SUBJECT: Triangle Expressway Southeast Extension (Complete 540) from NC 55 Bypass in Apex to US 64/264 (I-87) in Knightdale, Wake and Johnston Counties; Federal Aid No. STP-0540(19), STP-0540(20), and STP-0540(21); WBS Nos. 37673.1.TA1, 35516.1.TA1, and 35517.1.TA1; STIP Project Nos. R-2721, R-2828, and R-2829

From: [Alsmeyer, Eric C CIV USARMY CESAW \(USA\)](#)
To: [Ridings, Rob](#); [Thomson, Nicole J](#); [Riffey, Deanna](#)
Cc: [Abi Sheffey](#); [Matthews, Monte K CIV USARMY CESAW \(USA\)](#)
Subject: [External] RE: R-2721A (540) Site 33 In-field Mod
Date: Wednesday, June 21, 2023 12:24:45 PM
Attachments: [image003.png](#)
[230615 Mod Drawings Mod10 I-540 R-2721A Wake.pdf](#)

Change 650 linear feet of permanent stream impact from riprap-lined ditch, to Piped impact. Impact is already mitigated for and no change to amount of impacts is proposed. This is for Site 35 on section R-2721A of the Complete 540 Project.

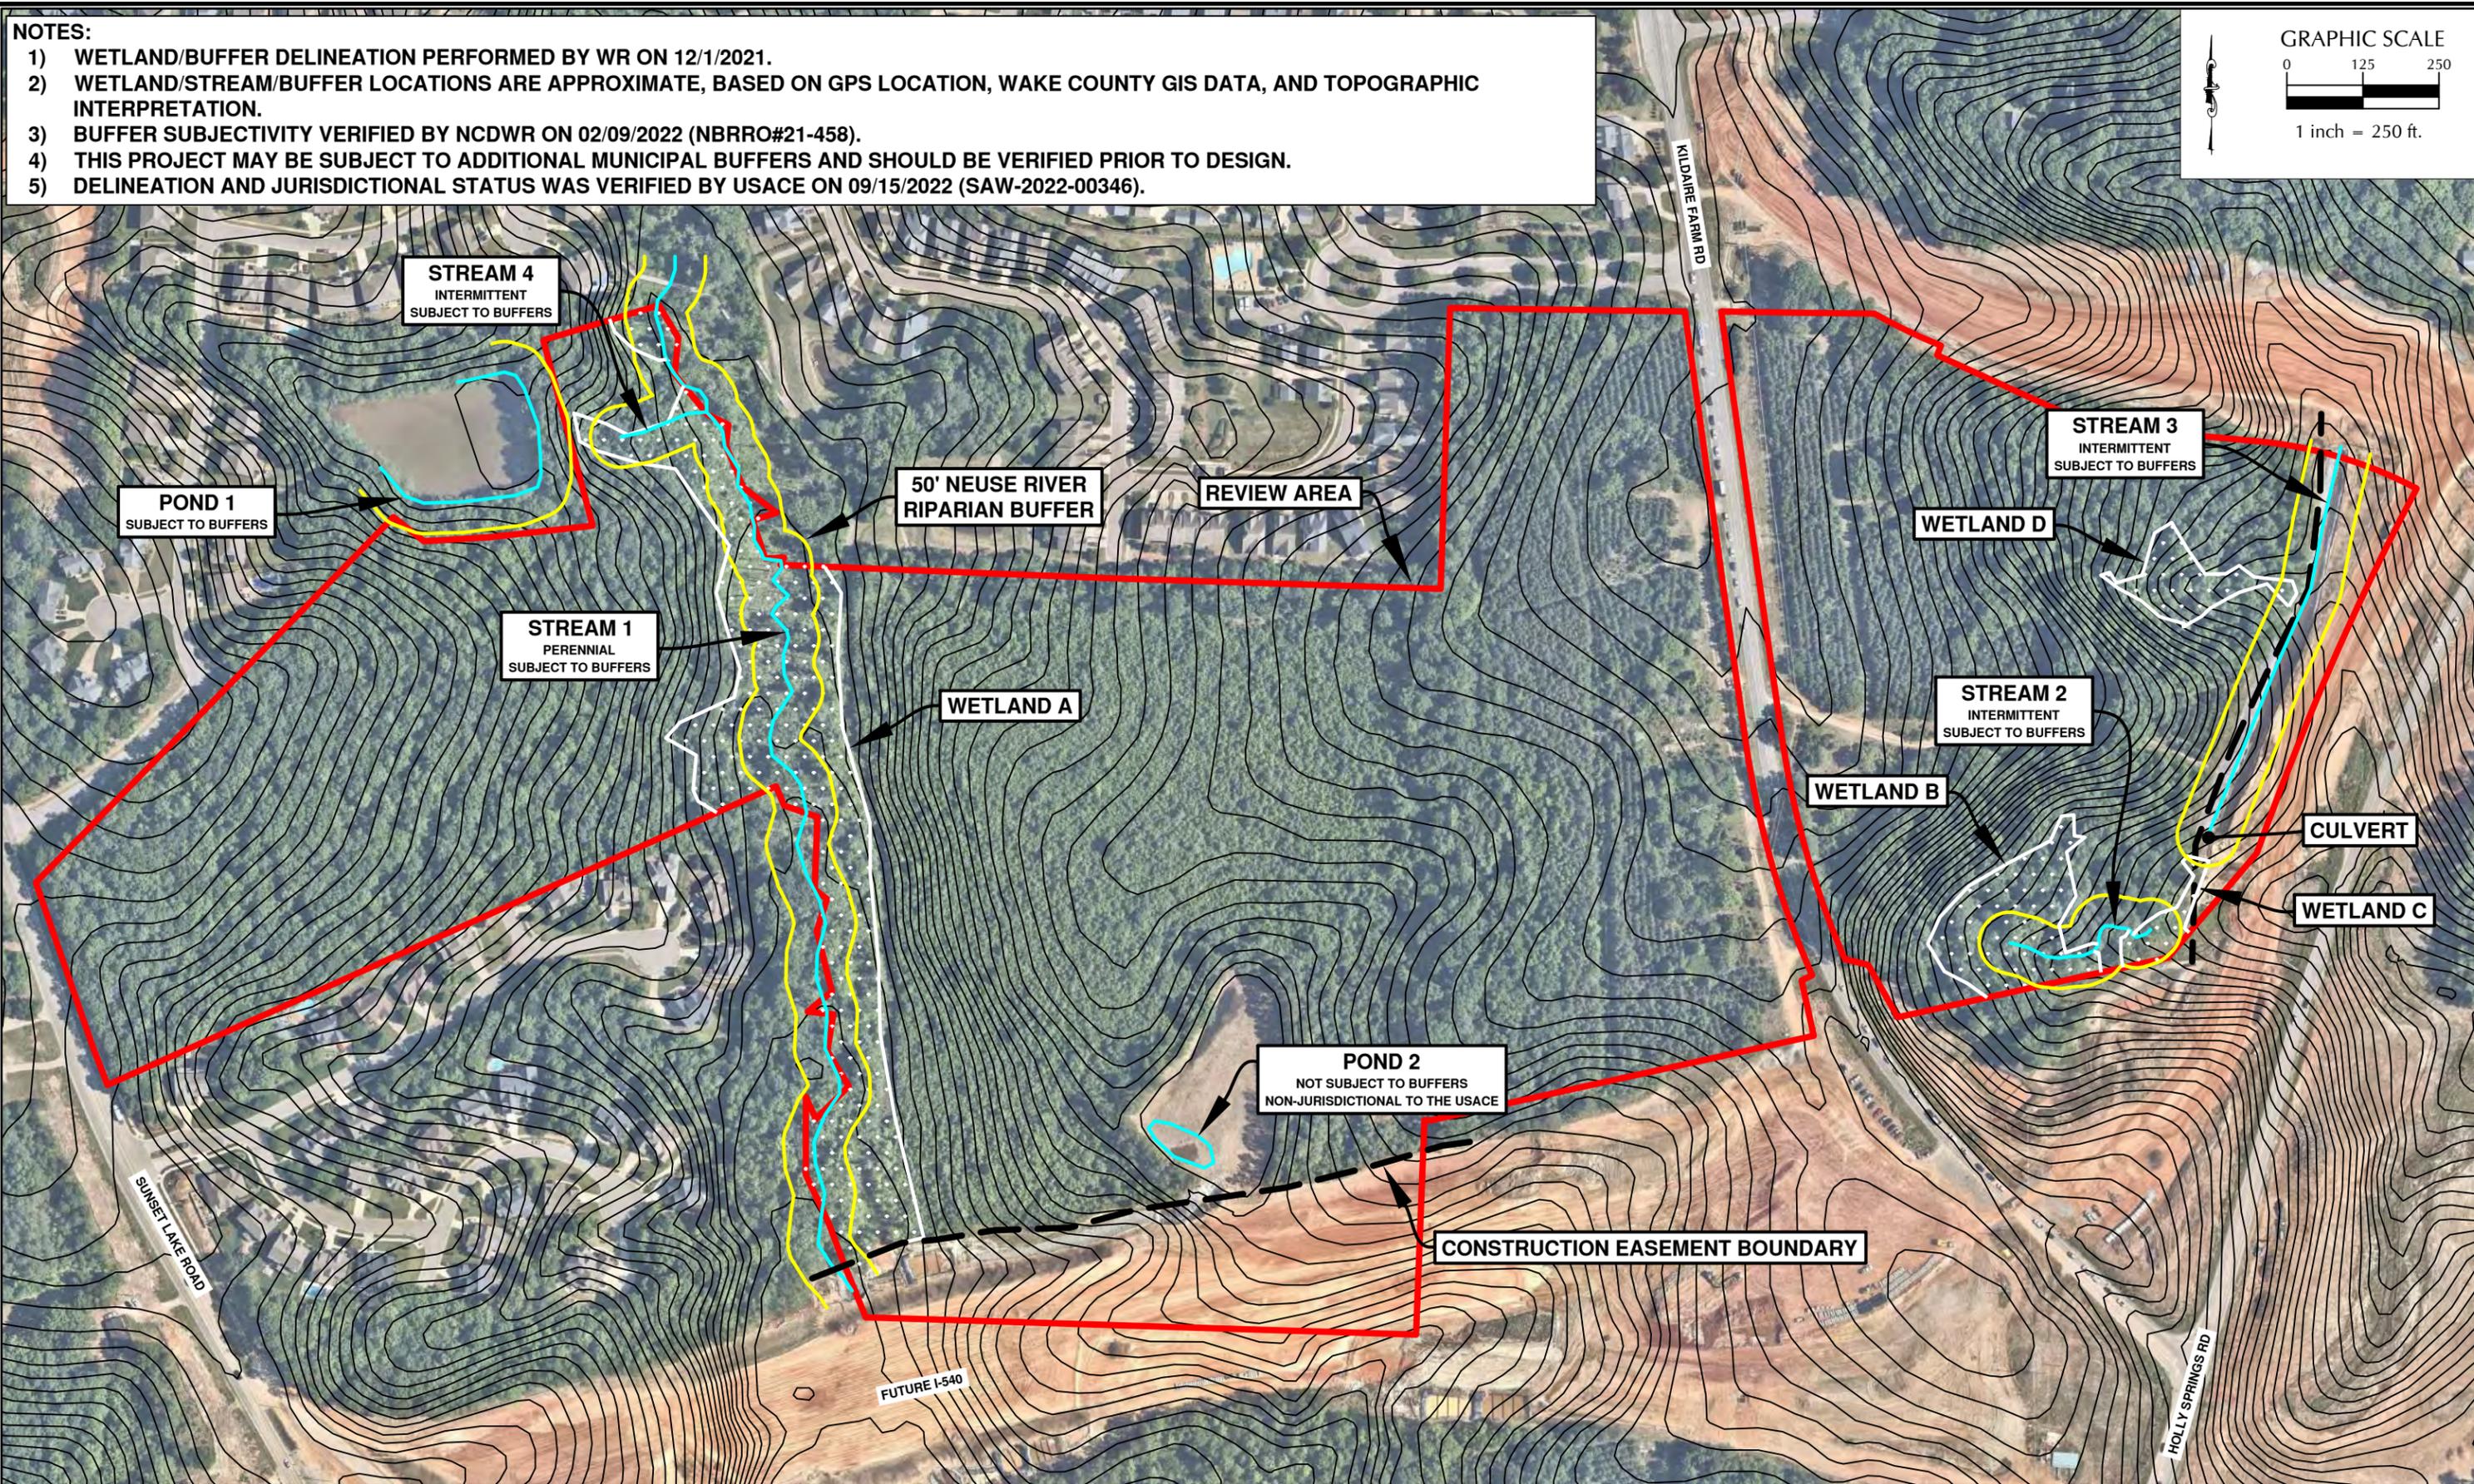
Design-Build Team wishes to extend the fill slop to adajacent property for three stated reasons. (1) Future Maintenance: Difficulty getting access for maintaining and cleaning riplined ditch after project completion. (2) Vehicle & Pedestrian Safety: sidewalks parallel to open ditch next to seep slope is current plan and this change creates more safety. (3) Future Utility Access: poles located near toe of slope require traversing steep slopes to perform maintenance.

- 1. As-built drawings of the proposed action shall be submitted to the NC DWR Transportation Permitting Unit within 30 days of completion of the action.**
- 2. All the authorized action activities and conditions of the certification associated with the original Water Quality Certification dated 02/15/2019 and all other corresponding modification still apply except where superseded by this certification.**
- 3. Modified Site (#33, section R-2721A) shall be constructed in manner requested by NCDOT in accordance with the request dated June 15, 2023 and in manner with the referenced Reclamation Plan and Agency Field Meeting Minutes. Any variation will require an additional modification.**
